DRAINAGE AND TRANSPORTATION SHEET
(REV. 1/28/2003rd)

PROJECT TITLE: Bruckner's Truck Sales ZONE MAP/DRG. FILE # J-09-Z
DRB #: 1008585 EPC #: _____ WORK ORDER #: _____

**RE: BRUCKNER'S TRUCK SALES,
DRAINAGE REPORT AND GRADING PLAN COMMENT RESPONSE
ENGINEER'S STAMP DATED: 7/19/12 (J09/DO21)**

ENGINEER'S SEAL RONALD R. BOHANNON P.E. #7868	BRUCKNERS TRUCK SALES		DRAWN BY BJF
	DETAIL SHEET		DATE 9/20/12
	TIERRA WEST, LLC 5571 MIDWAY PARK PLACE NE ALBUQUERQUE, NM 87109 (505) 858-3100 www.tierrawestllc.com		2011073_GRB
			SHEET # C9

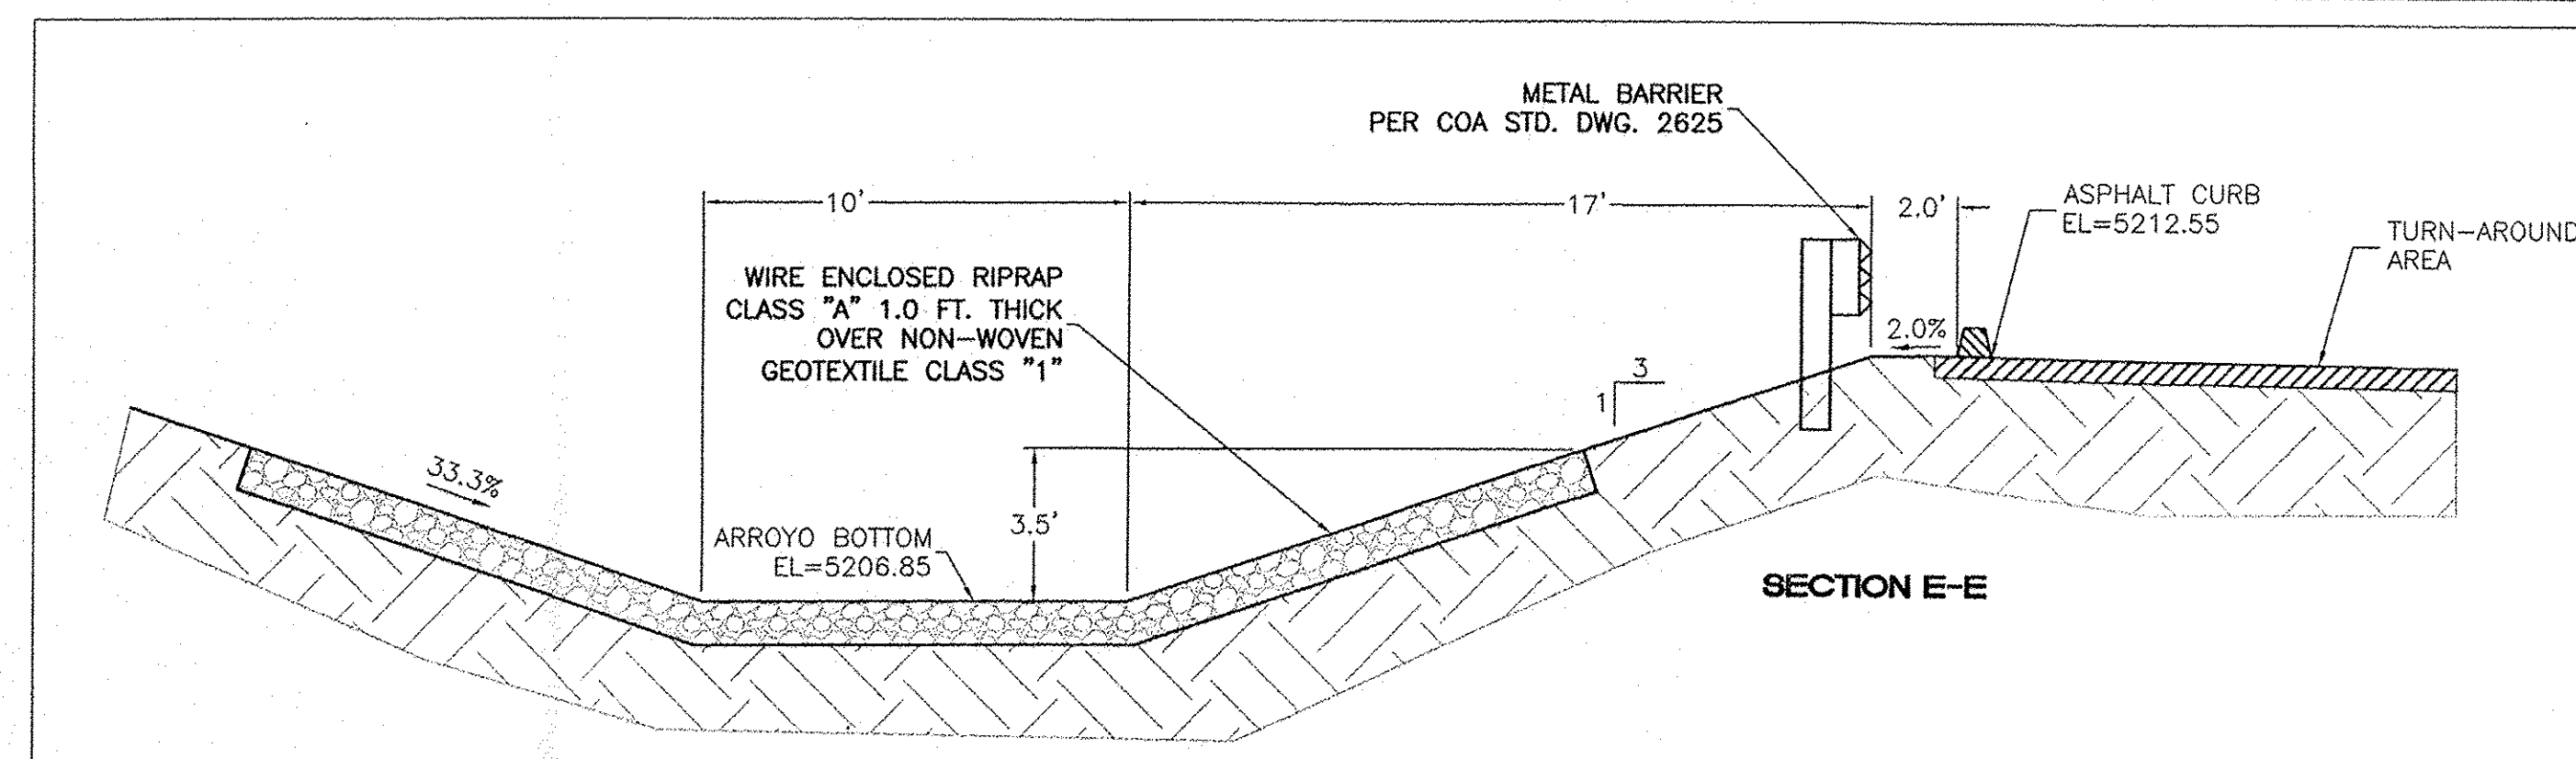
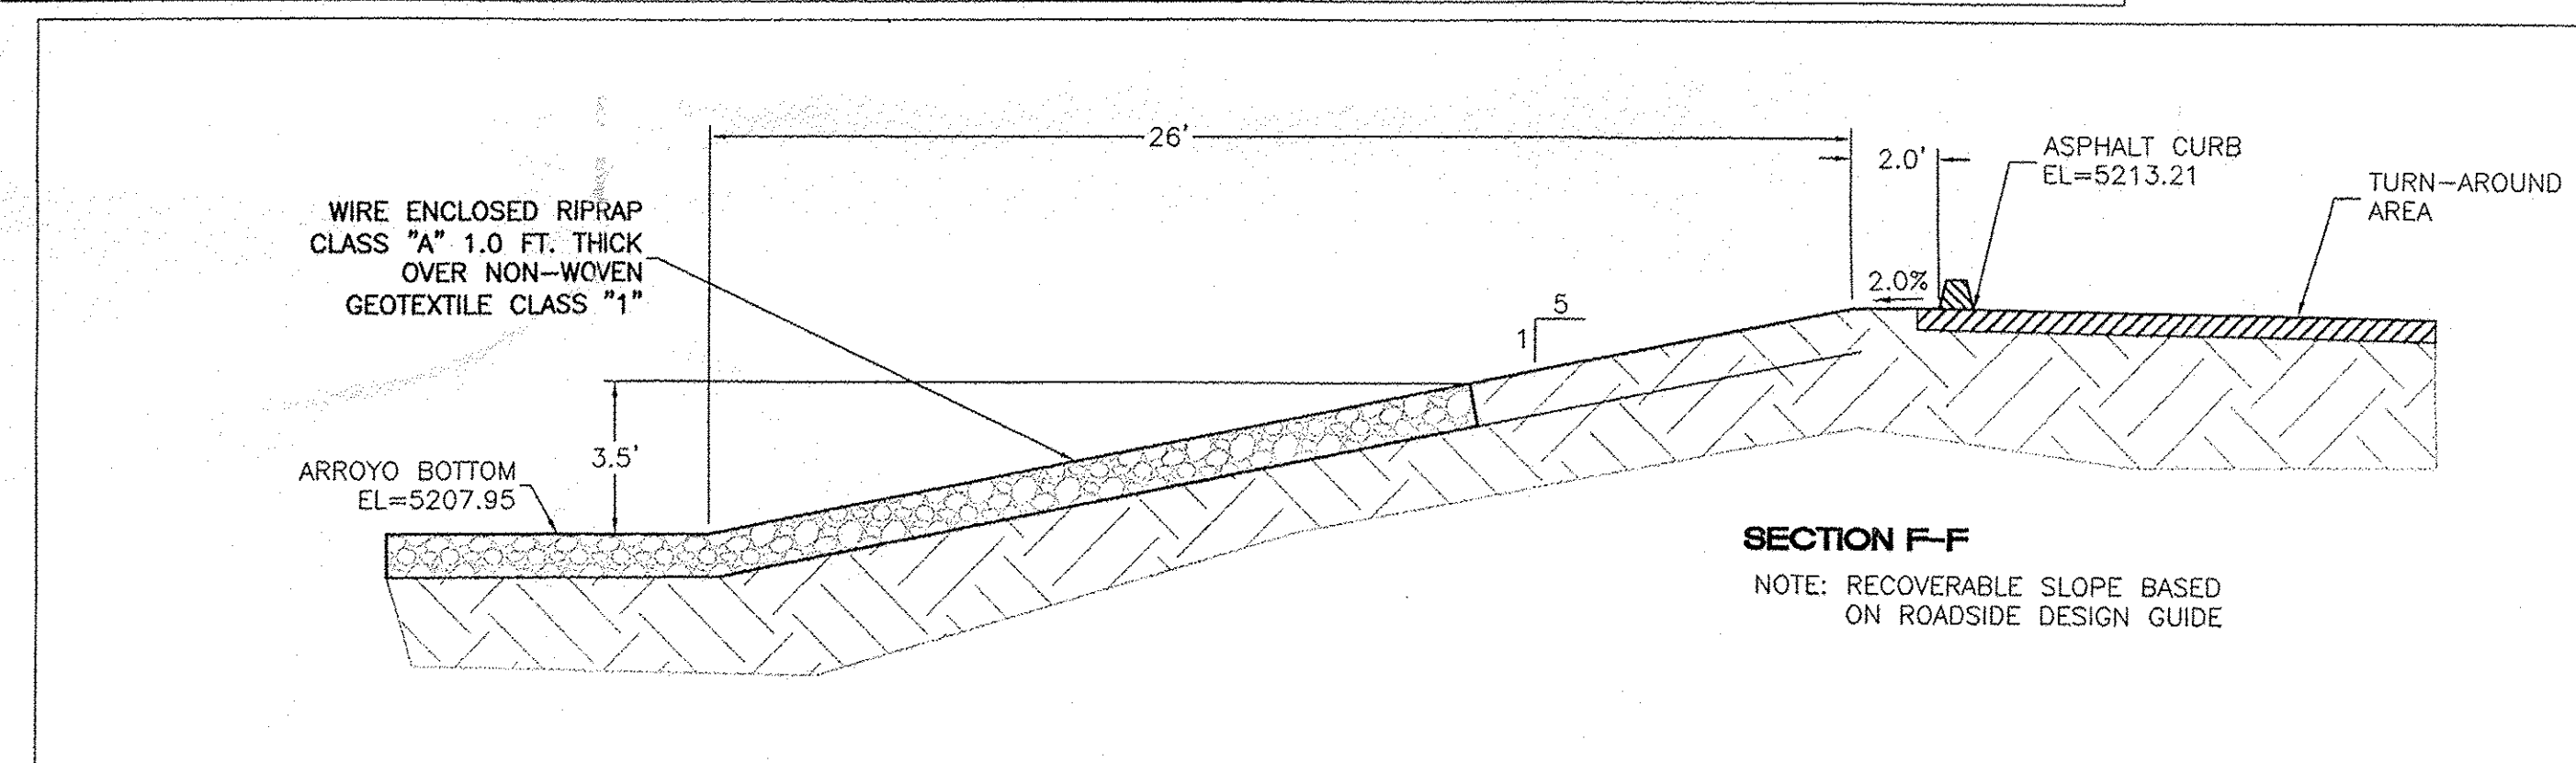
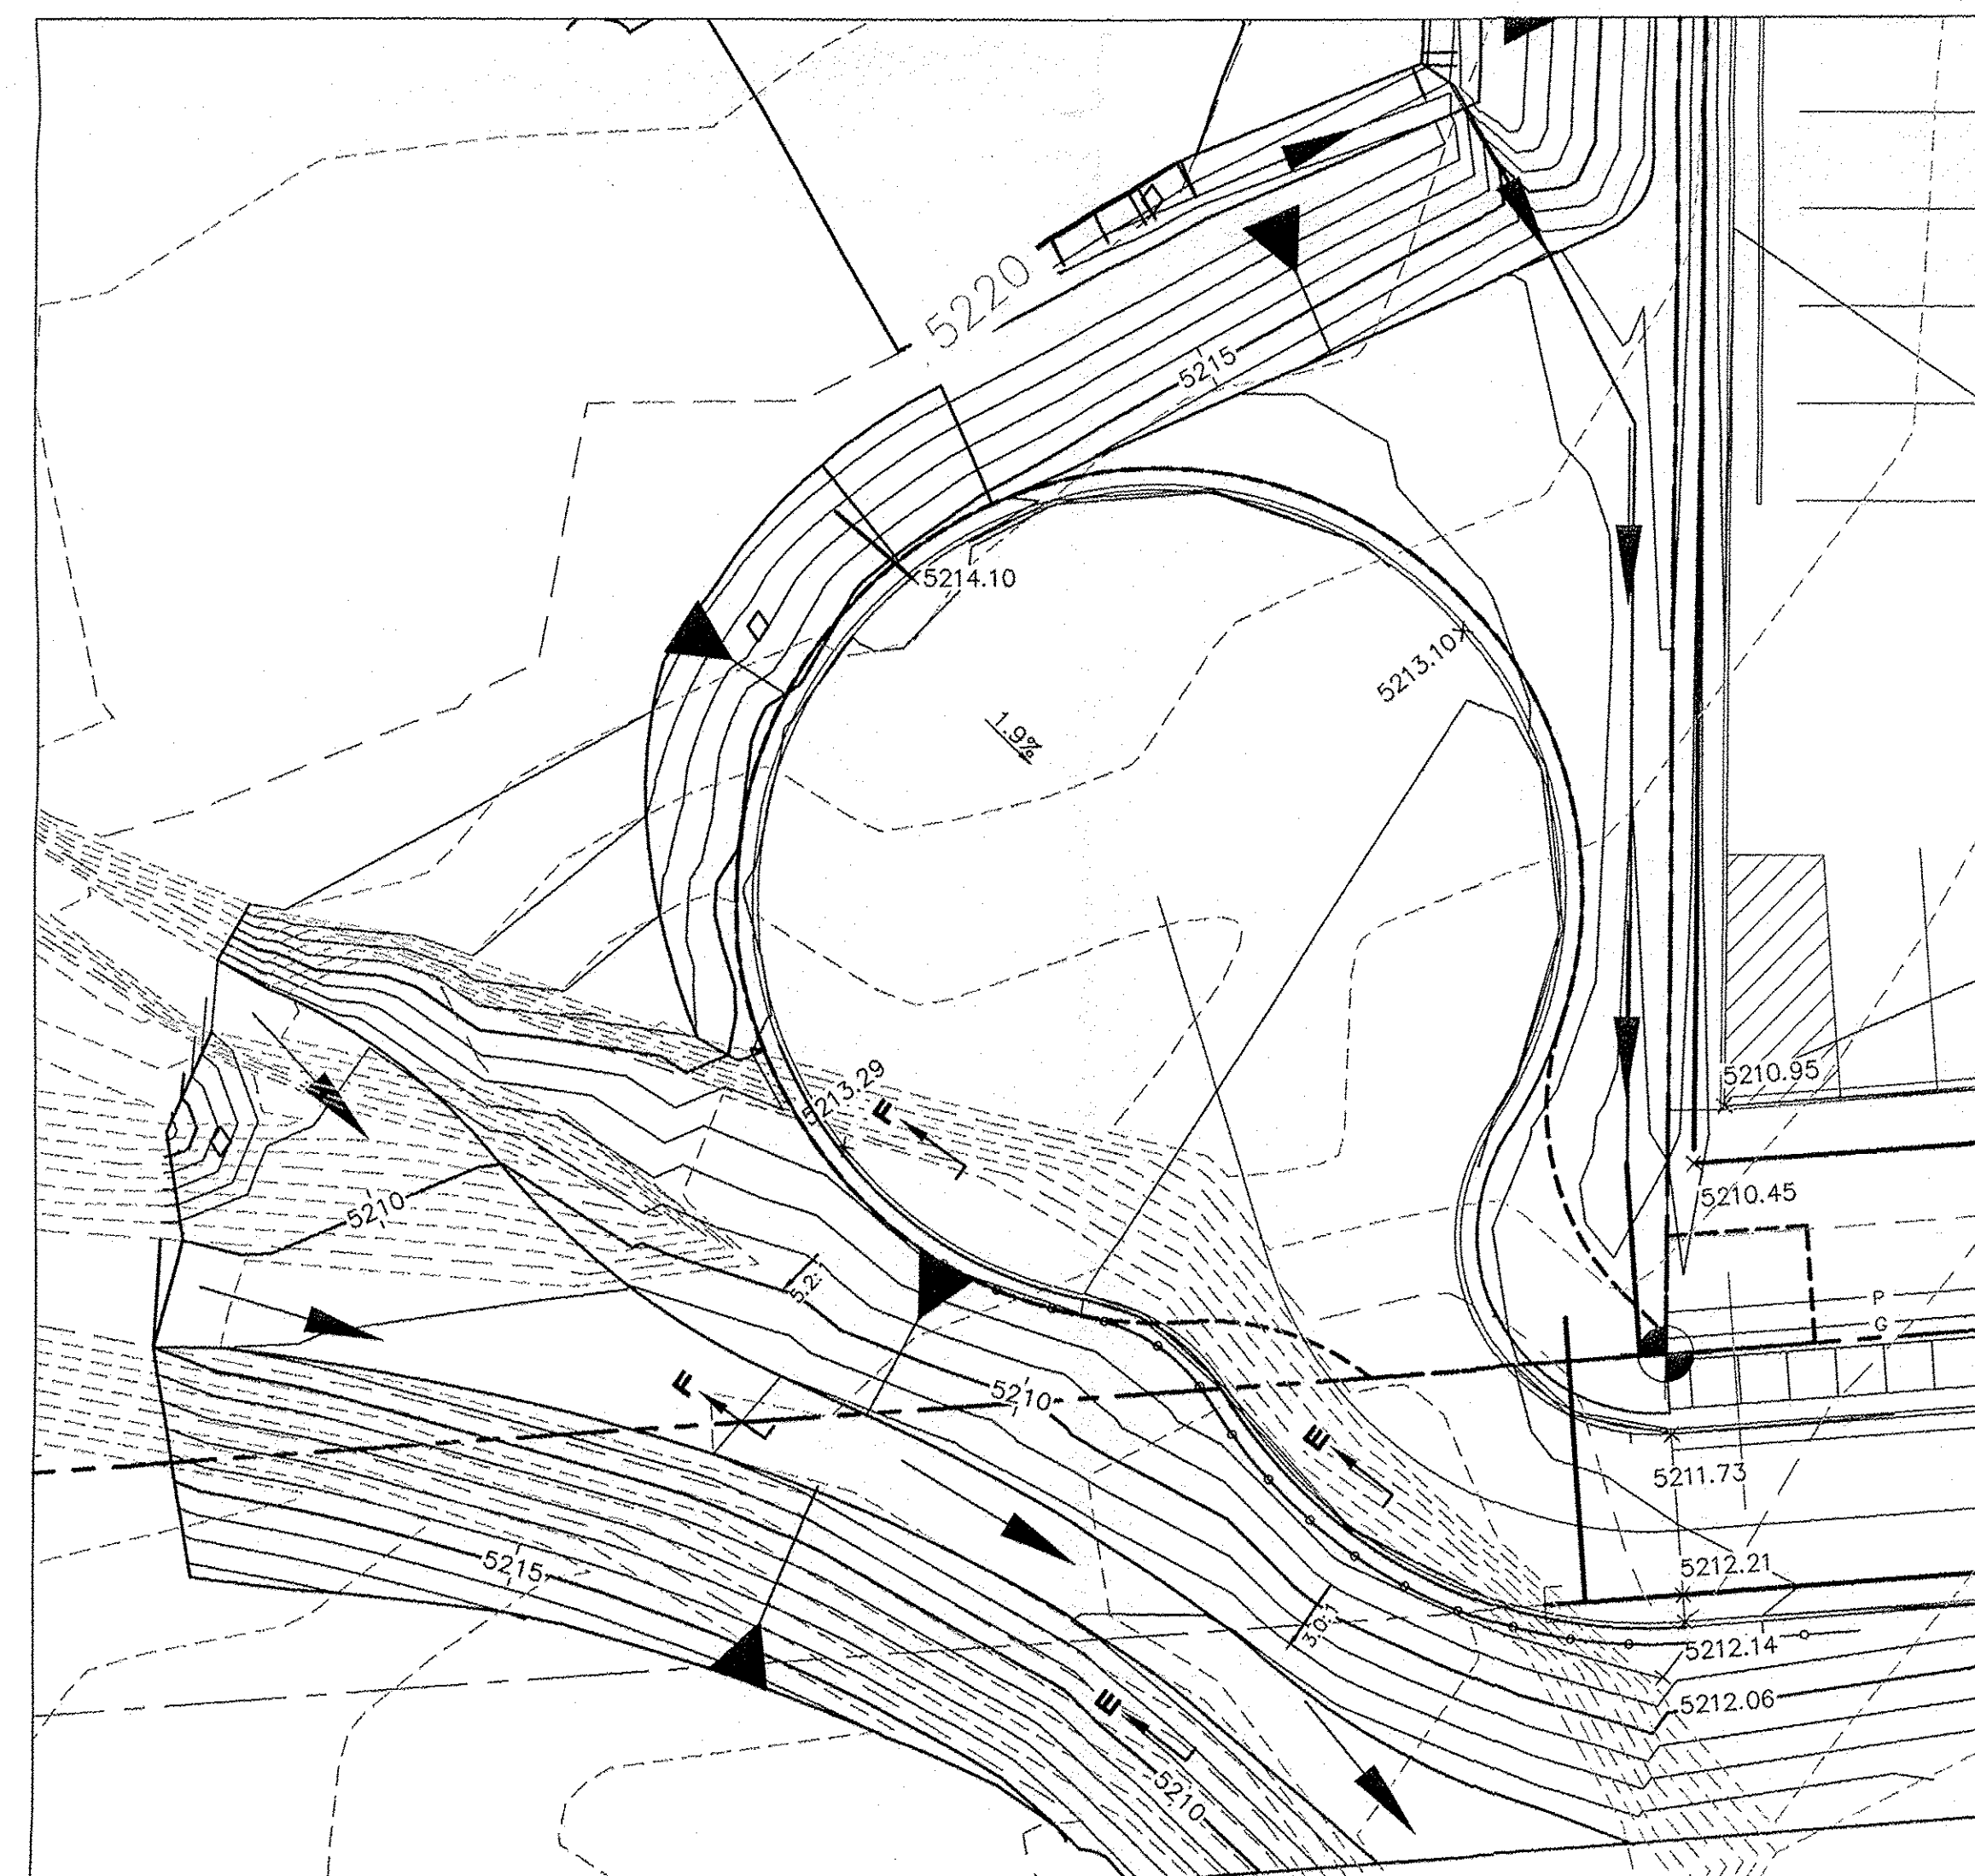
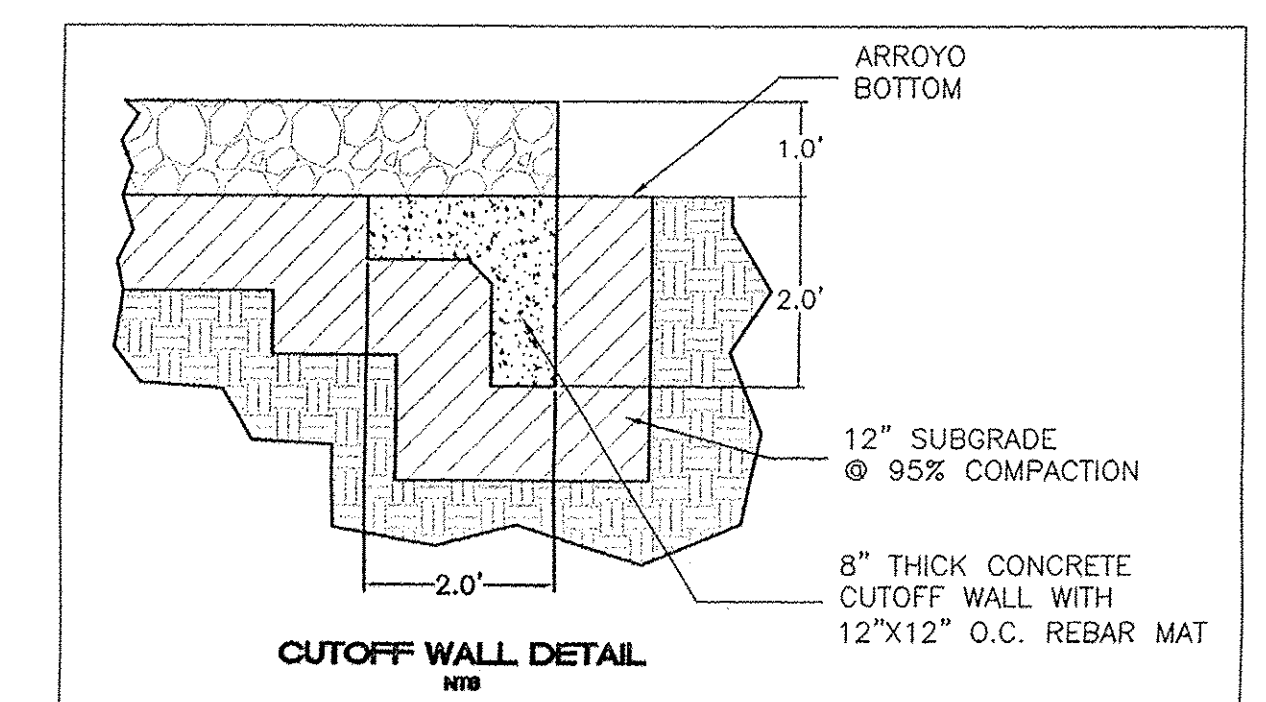
3. Please provide erosion and scour analysis passed the enclosed riprap for the channel. Would scour wall be required at the end of the riprap?
Attached, please find the channel analysis results for the area in question. The analysis shows that the velocities are within the acceptable range to prevent dangerous erosion and we have called out and detailed a cutoff wall for the end of the riprap and channel improvements.

< 5 fps, therefore okay
